The Town of Erie

To: Heidi Majerik, Erie Land Company LLC
From: Hannah Hippely
Date: February 7, 2019
Re: SK-001023-2018 – Dearmin Sketch Plan No. 2 Application

The Sketch Plan application process allows staff, Planning Commission and the Board of Trustees the opportunity to make comments regarding an application early in the development that the applicant should then address with the Preliminary Plat application. Below are the Community Development Department comments. Some of the information below is related to the next steps of the zoning and subdivision processes.

Figure 1a

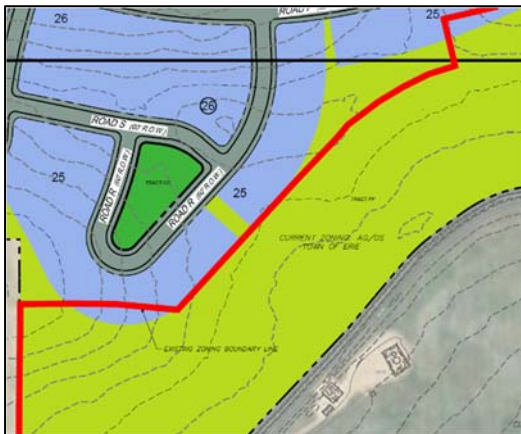
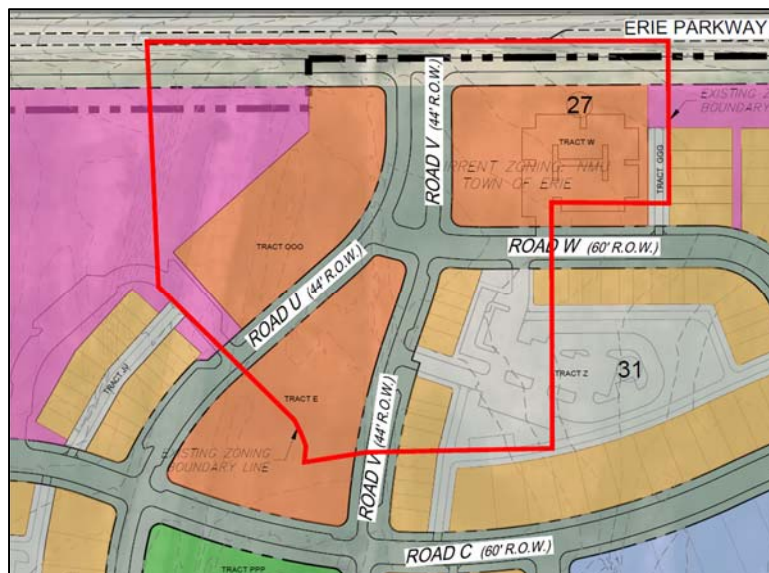
3. The property is currently zoned NMU, LR and AG-OS. The sketch plan proposed would require that the current boundaries be adjusted.
 - a. In Figure 1a and 1b below, the red line is the current boundary between the Low Density Residential (LR) District which is located above the line and Agricultural/Open Space (AG/OS) District located below of the line. In this sketch plan residential lots are proposed within the area zoned AG/OS and these areas would need to be rezoned to permit this.
